No: 25-013

DAUPHIN COUNTY SUBDIVISION/LAND DEVELOPMENT REVIEW REPORT

Municipality Derry Township Surveyor Herr Engineer/RLA Not Indicated

Plat Title Scott R Ortenzio & Celeste C. Stalk-Ortenzio

PROPOSED

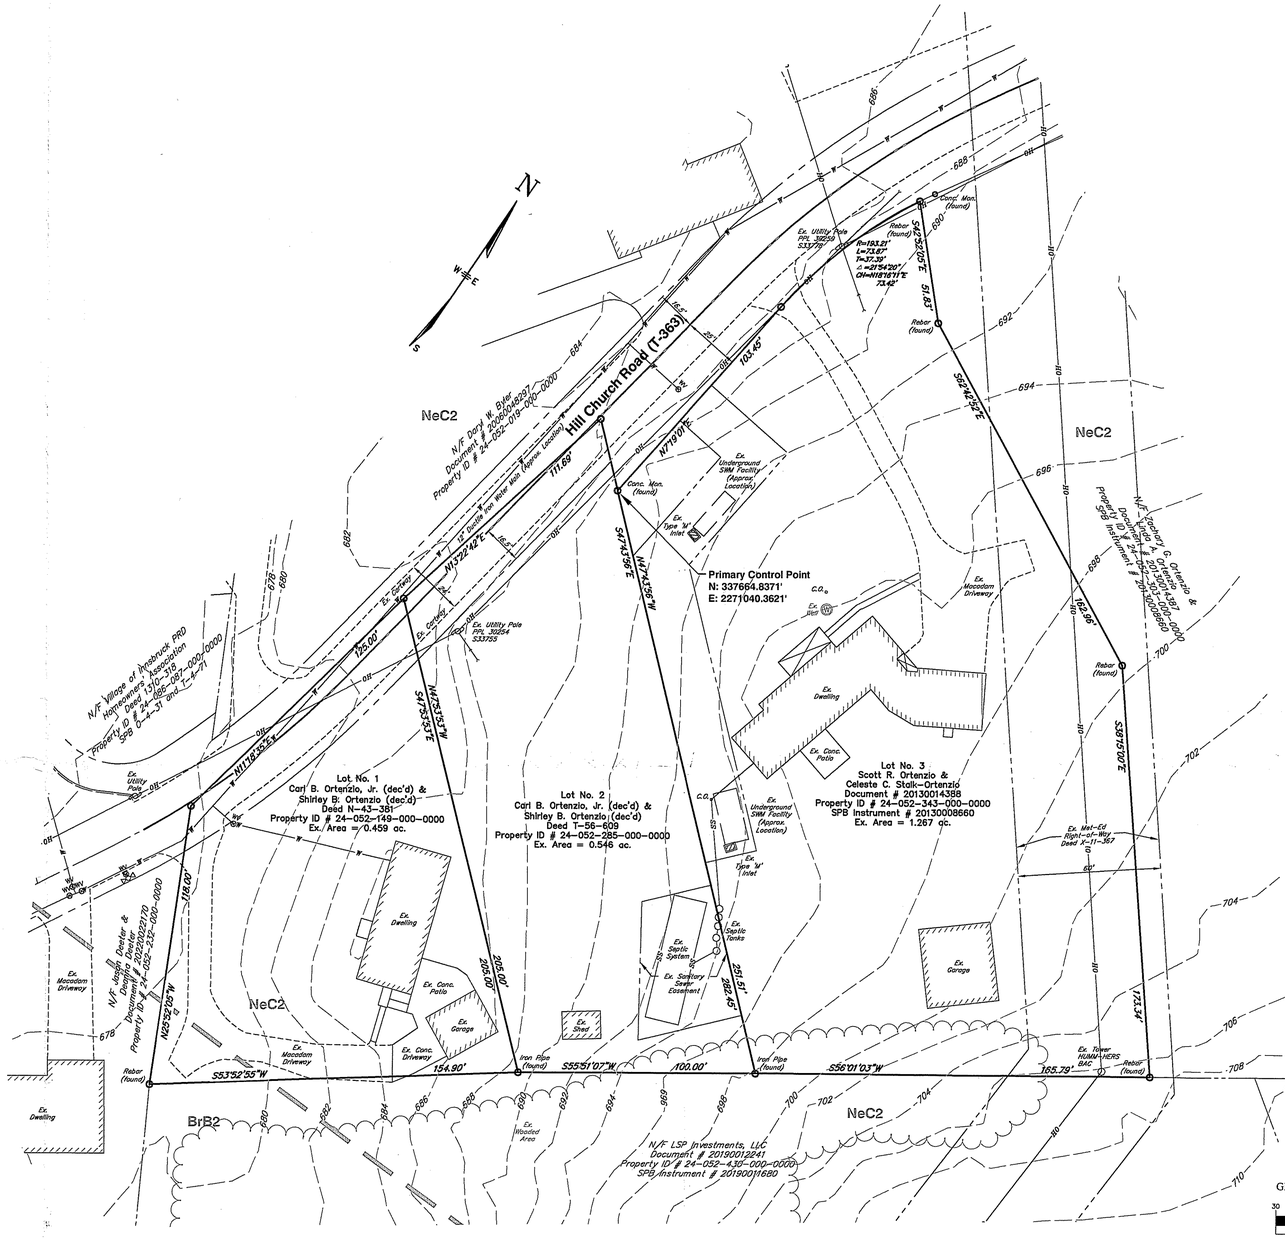
2. Show sewage facilities associated with Lot 1 on plan [S-LD §185-13E(4a)(20)].

3. Provide the zoning district classification of abutting land [S-LD §185-13E(4a)(37)].

4. Existing garage and shed structures are located in required setbacks. Confirm if a variance is required, or if this is considered an existing non-conformity.
